# Laurel Heights Improvement Association of San Francisco, Inc.

December 14, 2018

Re: State Clearinghouse No: 2017092053 - 3333 California Street Project  
Application for Environmental Leadership Development Project

3333 CALIFORNIA STREET SAN FRANCISCO, CA

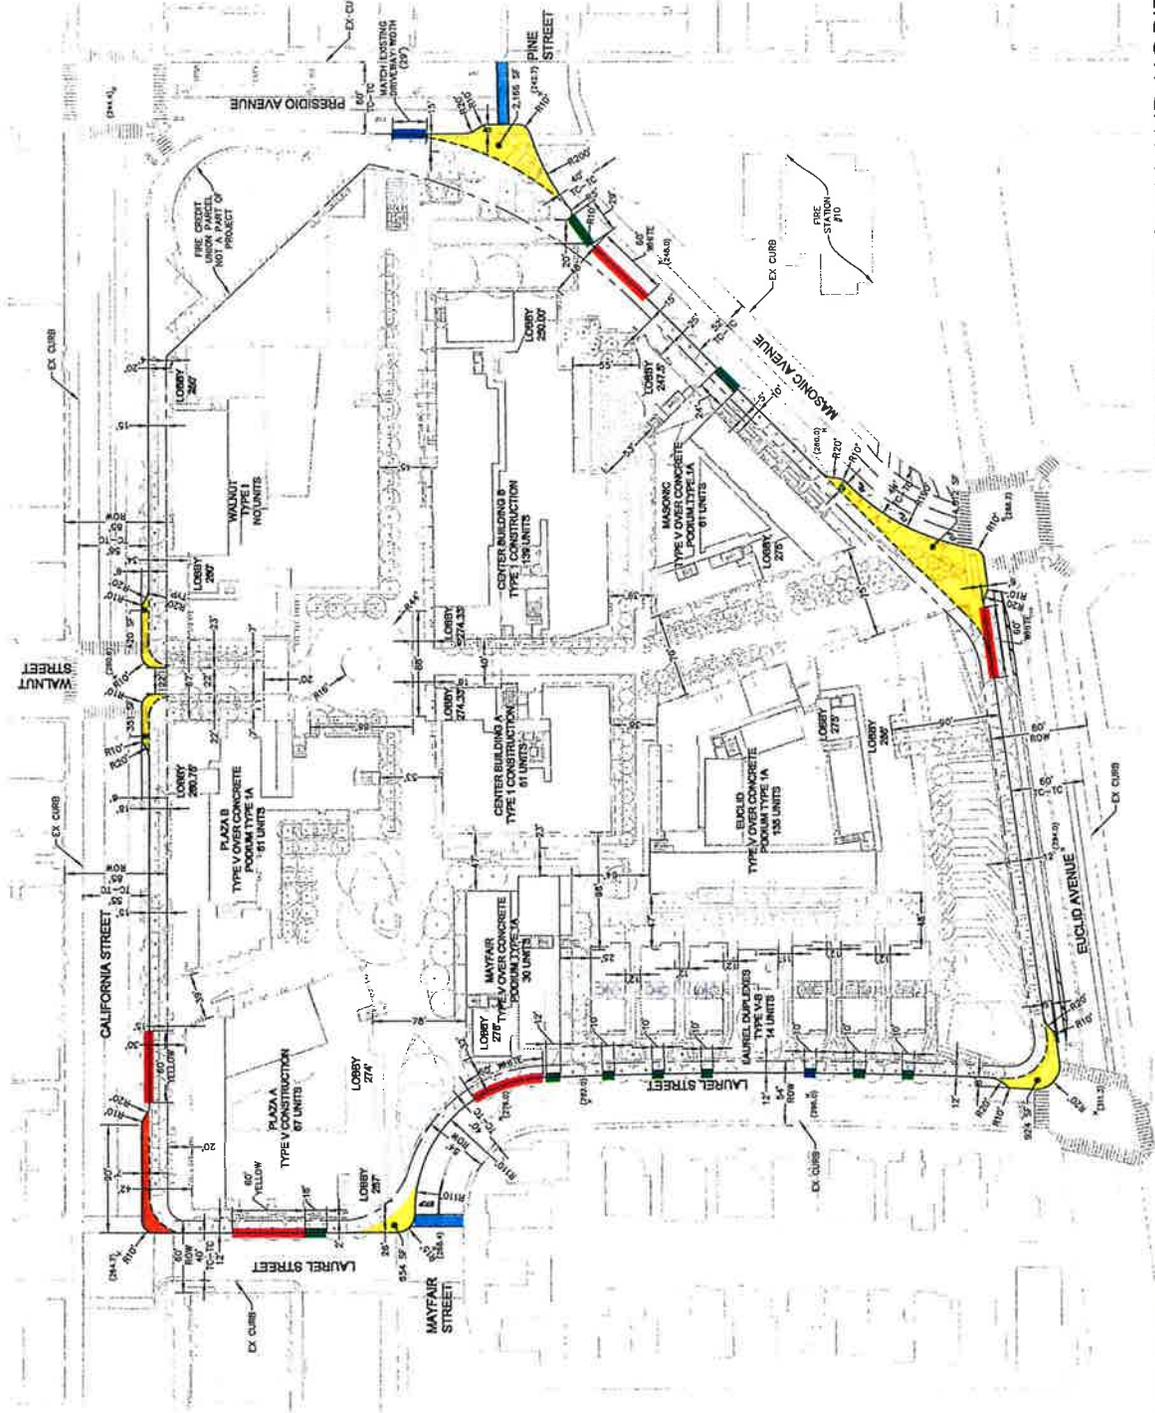
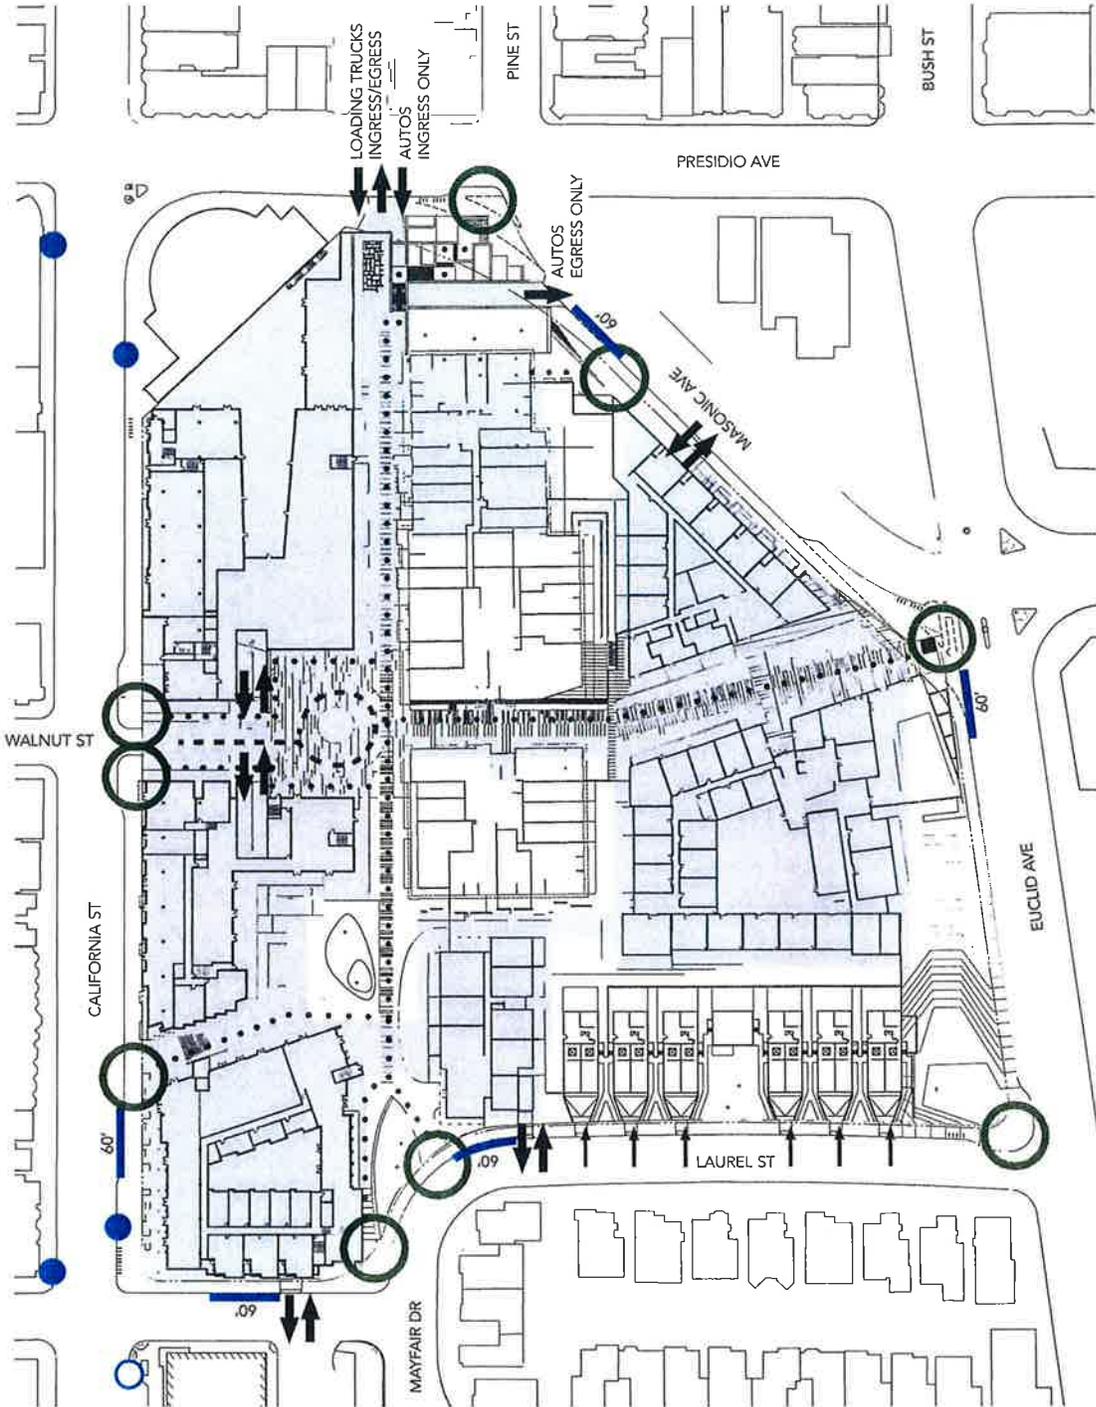
The project drawings submitted with the application do not show the new passenger and commercial loading zones proposed for the exterior of the site, which would be used for pick-ups and drop-offs by passenger and commercial vehicles, including transportation network companies such as Uber and Lyft. These passenger loading zones can be expected to be used by employees working at the site as well as residents and visitors.

Attachment A hereto contains the 8-17-2017 plan sheet C2.02, which shows four (4) new proposed passenger loading zones and one (1) new commercial loading zone marked in red on the exterior of the site. Plan sheet L1.01 shows them marked in blue. (See Attachment A)

**A6.00**

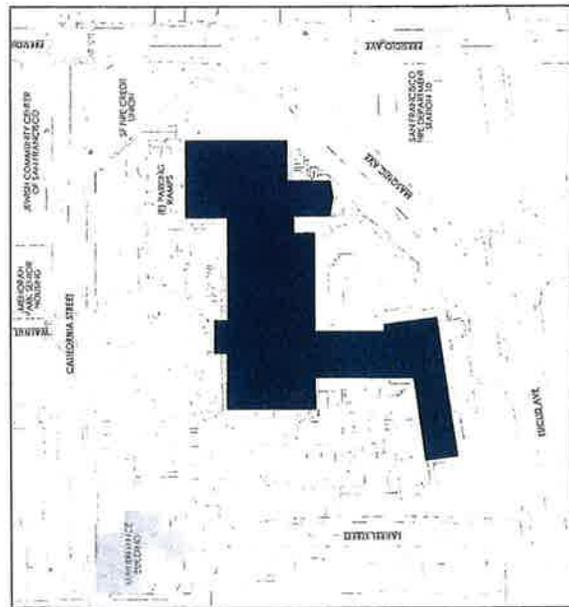
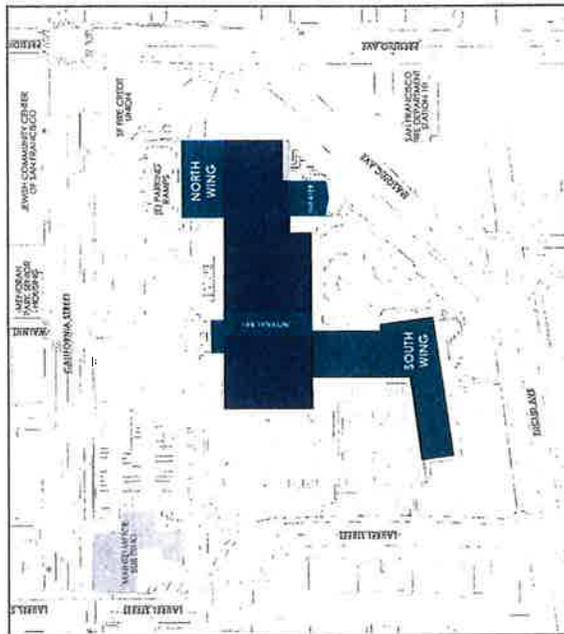
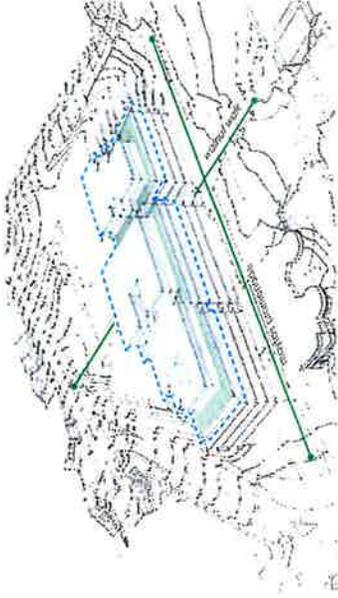
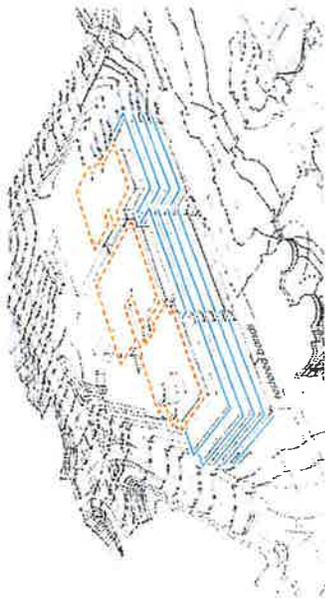
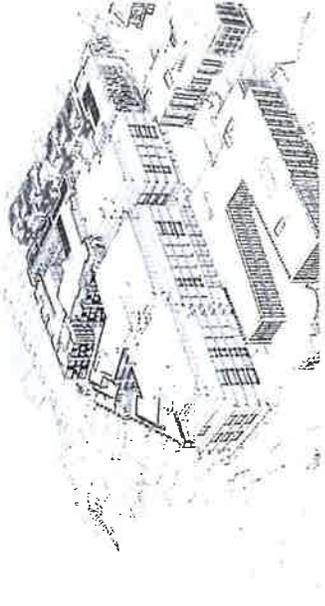
The proposed and variant project would materially impair character defining features of the resource including the horizontality of massing and the integrated landscaping. Attachment G, plan sheets A6.00, A6.01 and A1.02)
